NMAC 20.2.50.113

Justin Lisowski | Valor EPC

Direct Testimony

NMAC 20.2.50.113
Engines & Turbines

LEC (Prechamber Ignition) and SCR

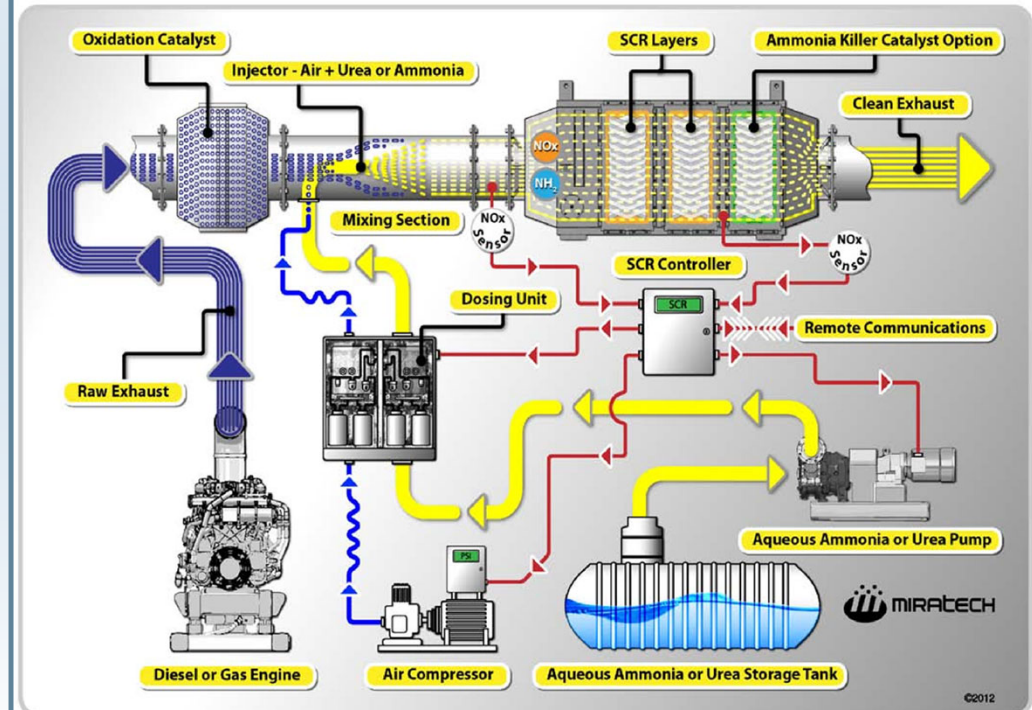
- **Low Emission Combustion (LEC) Technology**
 - More complex than a blanket solution for existing engines
 - In this context, applies to Lean Burn engines only

- Many factors for applicability include engine model and architecture, vintage, etc.
 - Hoerbiger (Cooper Machinery Services) low NOx upgrades are not widely applicable

- NOx “Adsorber” technology not commercially applicable
- **Non-Selective Catalytic Reduction**
 - Passive catalyst for rich burn engines, functioning by alternative rich/lean of stoichiometric

- Multipoint AFR controllers needed for tight control
 - Can achieve very low NOx levels but are limited by AFR set-points, natural drift, and catalyst degradation

- **Selective Catalytic Reduction (SCR) Technology**
 - Allows for NOx reduction in oxidative environment. Injects reagent downstream of engine (i.e. urea)

- Expensive to install and operate, disproportionately for smaller engines and/or turbines
 - Can be very complicated, requires on-site power that may not be readily available.

- Very limited, if any, instances of application in oil and gas gathering operations.

ERG - Compressor Seal Emission Impact

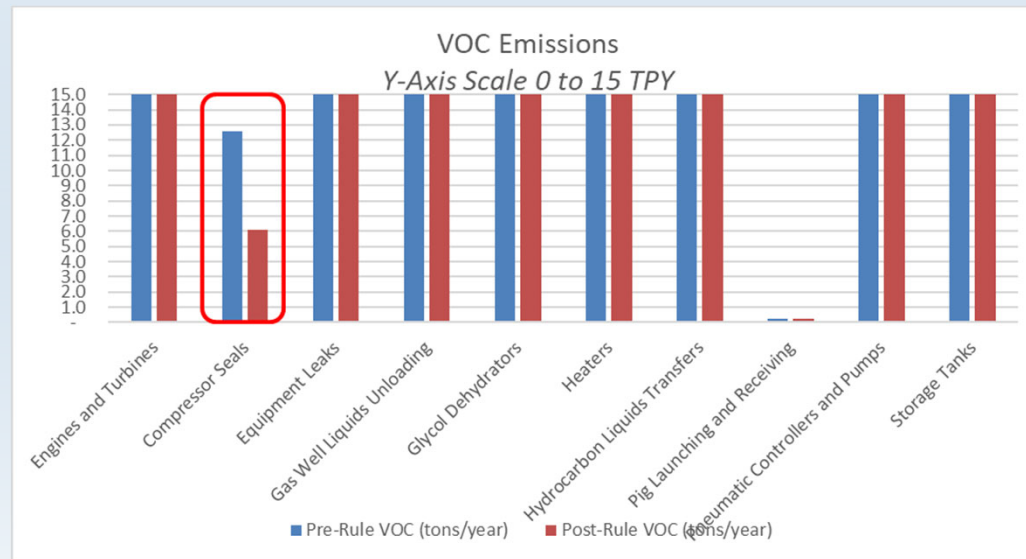
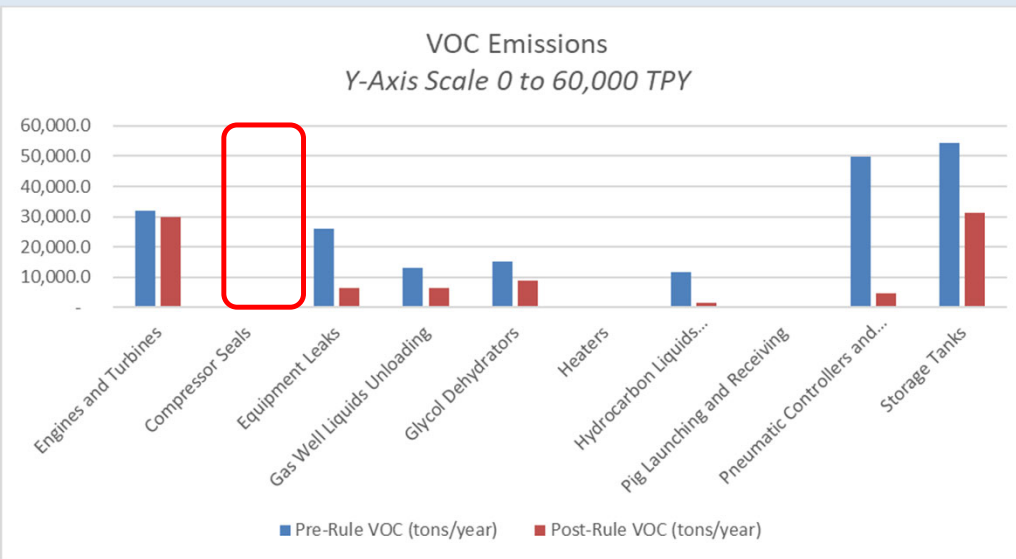
Mr. McNally testified that changes in the hundreds of tons of VOC emissions would not impact the emissions reductions achieved by the rule, indicating that eliminating this costly and burdensome rule and its 6 tons would not impact the reductions.
